**NOTICE OF A TYPE II DECISION ON A PROPOSAL IN
YOUR NEIGHBORHOOD**

**CASE FILE NUMBER: LU 08-122163 DZ – 910 NW 10TH AVENUE,
BANNER BANK ATM**

The applicant requests design review for the installation of an ATM machine within the existing concrete entry frame at the southwest corner of the Burlington Tower building located at NW 10th and NW Kearney. The ATM would serve the newly installed branch of Banner Bank which was recently approved under design review case LU 07-185754 DZ. The previous design review approval was for storefront renovations and the installation of a fireplace vent. The ATM was originally part of the earlier design review case but was removed so the tenant improvements could proceed. Design review is required for exterior alterations to buildings in design overlay zones.

2 EXTERIOR ATM WALL ELEVATION
SCALE: 1/2" = 1'-0"

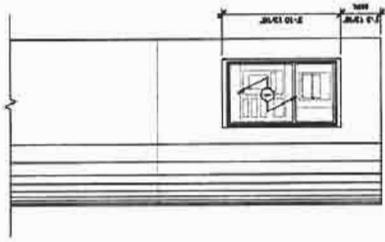
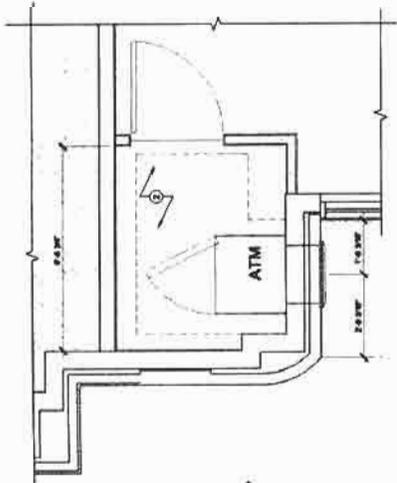
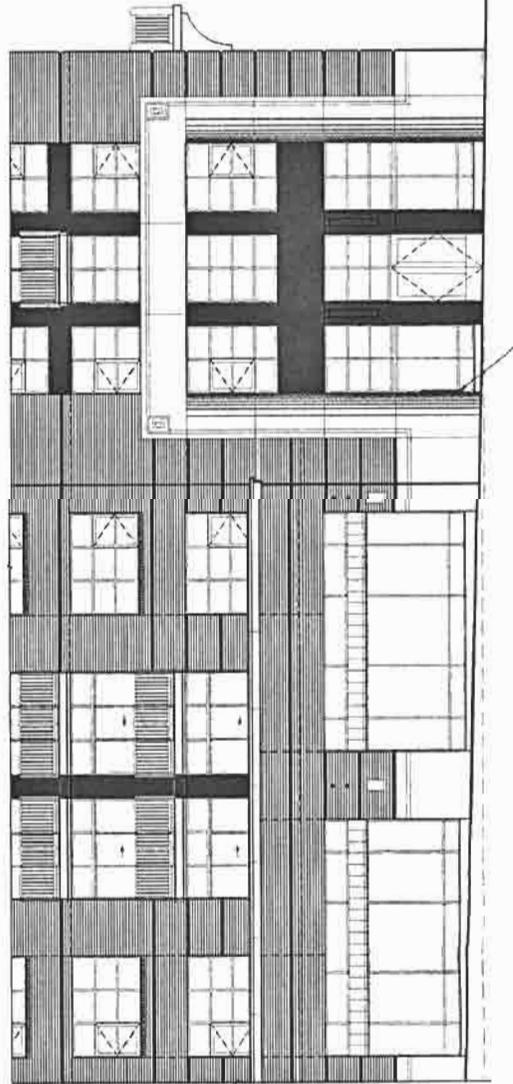
Findings: Locating the ATM in the base of the existing multi-story concrete frame would require the removal of a portion of the pre-cast panel. While this is structurally possible, cutting a hole in the entry frame creates a sense of impermanence and weakness in the building structure. The ATM itself is not a permanent or high-quality architectural feature and would detract from the entry frame. Removal of the ATM is a possibility and would leave a large hole in the pre-cast concrete base panel which would be difficult to repair since any new concrete would be poured at a different time, with different batch materials, and would not have aged-in-place like the original panel. Replacement of the entire panel would suffer from the same problems of trying to match new material to old material that has been in place for a number of years. *This guideline is therefore NOT met.*

DR3 064500 04.14.08

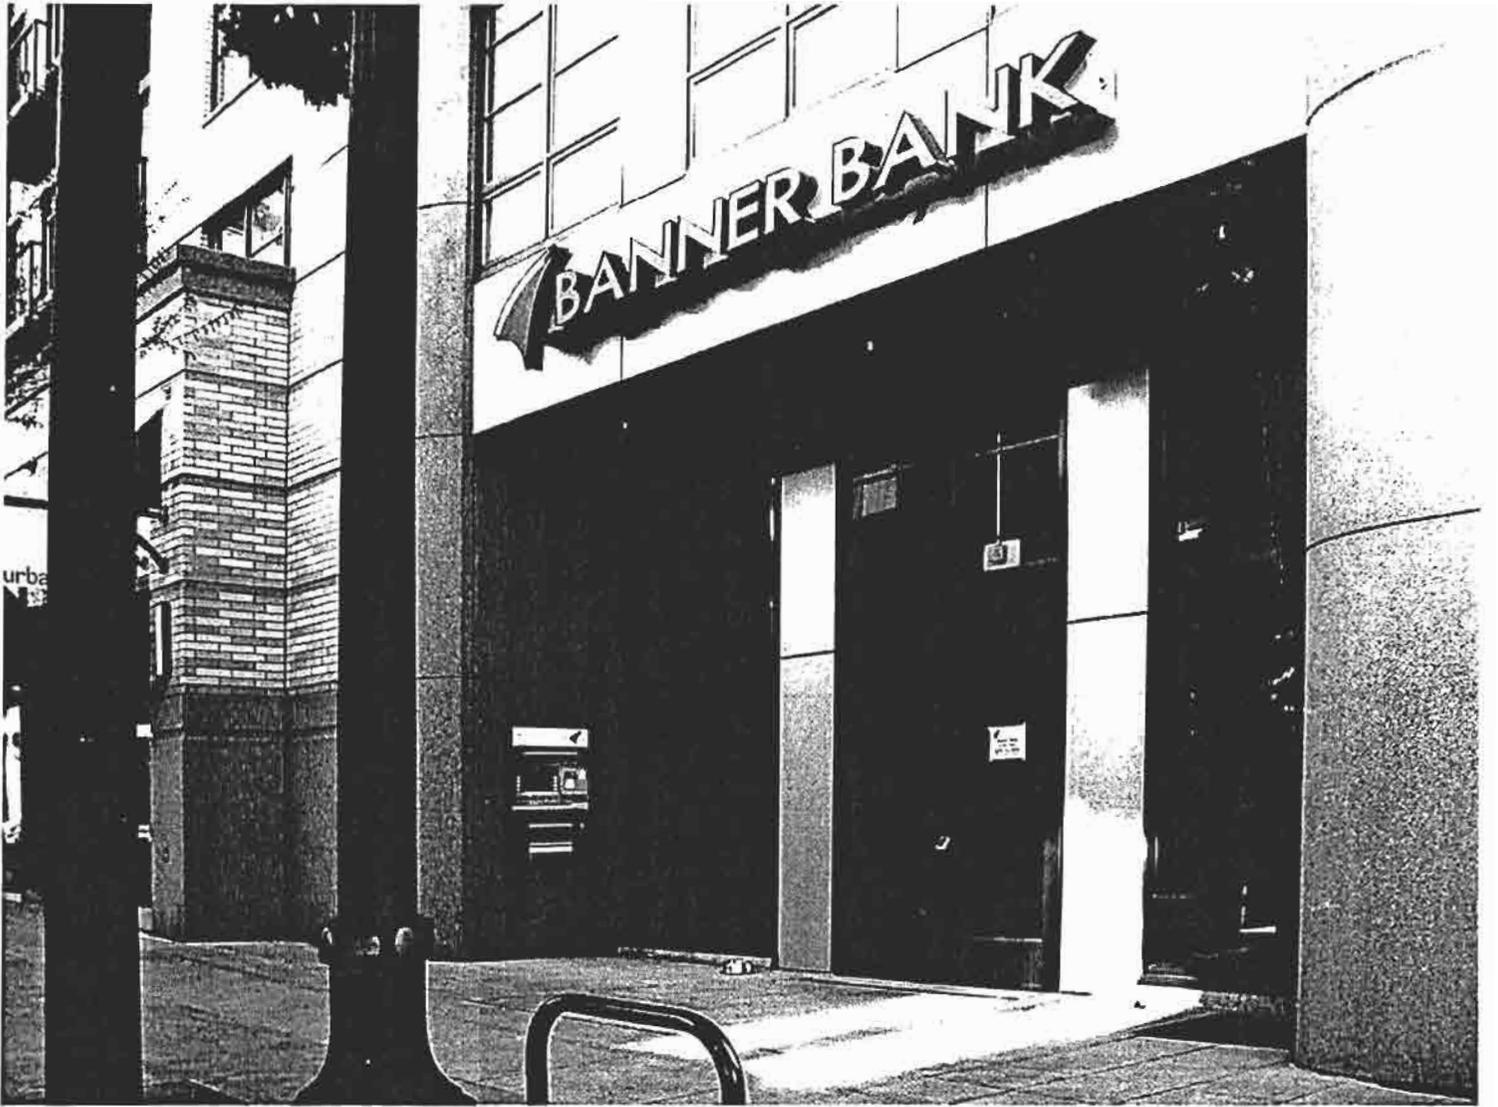
Findings for A5 and A5-1-1: The proposed ATM location at the base of the multi-story concrete pilaster violates the unified, monolithic tripartite composition of the building at this significant southwestern corner entry by breaking the continuous line of pre-cast concrete that surrounds the base of the building. *This guideline is therefore NOT met.*

Findings: The southwest entry corner is an important feature of the building and was designed to feel structurally significant with its multi-story concrete frame and storefront system, detailed edges that lead the eye toward the doors, the large overhead brackets, and deep soffits. Placing the ATM within the multi-story concrete entry frame violates the original character of the existing building by making the base seem permeable instead of solid and also by interrupting the visual connection between the upper and lower portions of the frame. *This guideline is therefore NOT met.*

Findings: There are a number of other banks within a one block walk of the project site. These banks all have exterior ATMs, all of which are placed within existing storefront systems. None of the nearby ATMs are placed within significant entry features. The proposed ATM location for Banner Bank within the most significant architectural feature of the building does not follow the local design vocabulary. The existing storefront system offers a minimum of four locations at or near the corner of the building in which to place an ATM machine that would avoid penetrating the pre-cast entry frame. *This guideline is therefore NOT met.*

Findings: The framed corner entry feature is a critical part of the overall building composition. It gives the building a sense of permanence, marks the entrances to retail spaces and is visible from several blocks away. Placing an ATM within the base of the framed corner entry violates the coherency of the original design and detracts from the perceived permanence and importance of the corner entry composition. *This guideline is therefore NOT met.*

The installation of an ATM machine within the pre-cast base of the dramatic two-story entry frame breaks the coherent architectural composition of the existing building. The proposed location is not typical of other nearby ATMs serving other local area banks. ATM machines are not high-quality or permanent architectural features and the proposed location for this particular ATM violates the permanence inherent in this significant and highly visible southwest corner entry. Repair or replacement of the compromised pre-cast panel with matching material would be extremely difficult if the ATM were ever removed, potentially permanently damaging the building's exterior. The existing storefront configuration at this corner of the building offers a minimum of 4 potential places to install an ATM without having to penetrate the pre-cast concrete entry frame.
